# Product Change Notification

**Change Notification #:** 109471 - 00  
**Change Title:** S5520HC, S5500HCV, S5520SC, PCN  
109471-00, Product Design, System Software  
Update, Processor Socket Pressure Plate  
Change  
**Date of Publication:** July 05, 2009

### Change 2)

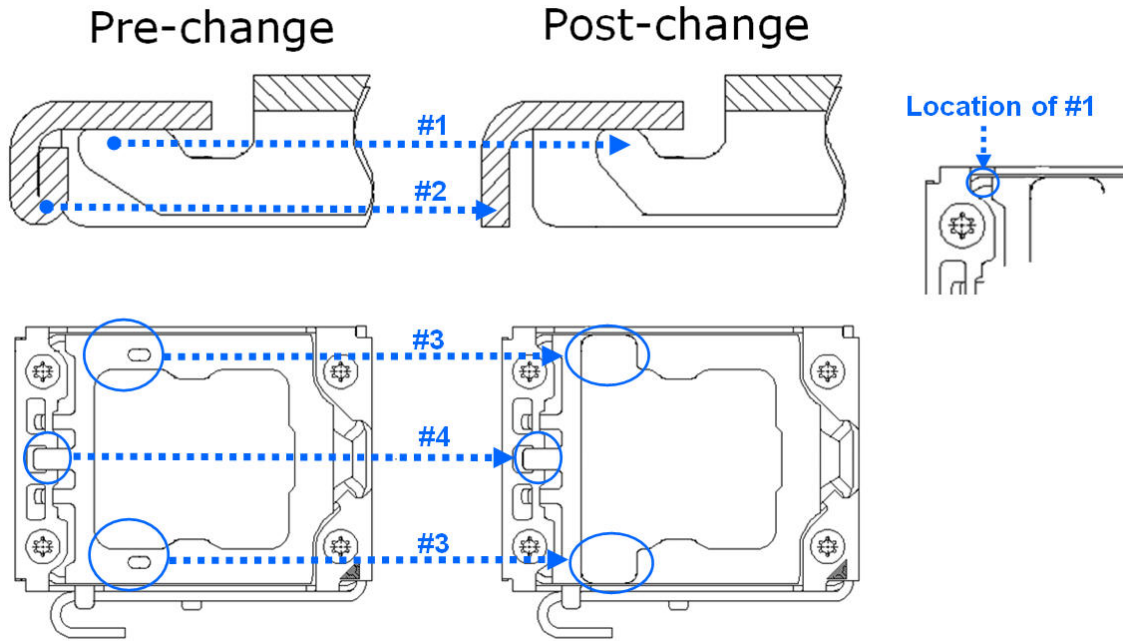
Intel is changing the pressure plate used on the processor sockets to a different version. This will accommodate future socket designs. There is no change to the fit, function, or operation of the processor socket. Changes made to the new pressure plate are:

- #1 - Shorten stop feature by 2mm.
- #2 - Remove "180 degree bend" from frame.
- #3 - Cut-outs are introduced to replace the slots to accommodate additional orientation posts of future sockets.
- #4 - Shorten tab by 0.5mm.
